ADDENDUM NO. 2

Date: October 3, 2018
Project: **MARINWOOD-HWY 101 TRUNK SEWER UNDERCROSSING
EMERGENCY REPAIR**
Job No.: **11200-03**
To: All Planholders and Prospective Bidders

1.2	Location	Marinwood-Lucas Valley Trunk	Diameter	18"	TV'd Ftg	417'
	Upstream MH	M000.51	Material	CMP	Total Ftg	417'
	Downstream MH	M000.49	Direction	DS

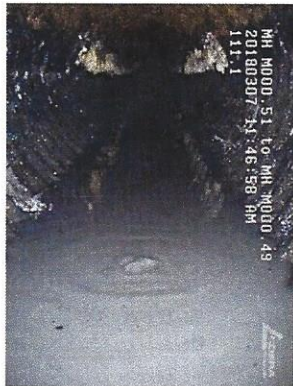
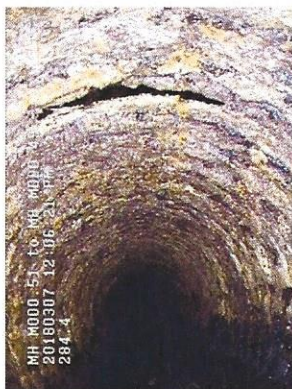
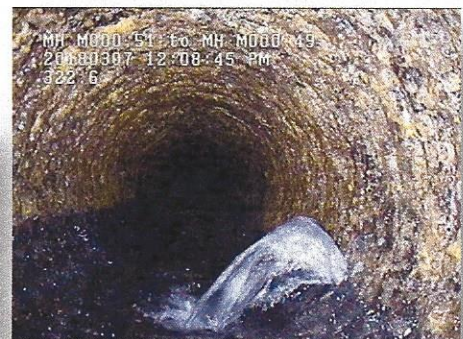
111' I/I under flow

119' Grease

153' Faulty joint seal

Holes in pipe wall at 246' & 284'

~~322~~ I/I gusher

Summary:	Corrugated pipe severely corroded however no deformations noted.
Recommendation:	Remove grease, seal active infiltration. Install Dynaliner PVC Thermoformed SDR35 Liner.

- 1) Regarding point repair required in Technical Specifications Section 02650-9, page 172, paragraphs 3.01.E and F, Contractor shall be responsible in correcting deficiencies in the existing sewer as shown in the attached CCTV inspection log prepared by MSI dated 3/16/2018. Contractor shall include in its bid an allowance for correcting the deficiencies that may prevent proper installation of the CIPP.
- 2) Interested parties may obtain a copy of the full CCTV inspection DVD at the District office by contacting Irene Huang at ihuang@lgvsd.org, or by downloading from the Dropbox link below. Note that the CCTV video being provided is for informational purposes only. Contractor is still required to televise the line as part of the project.
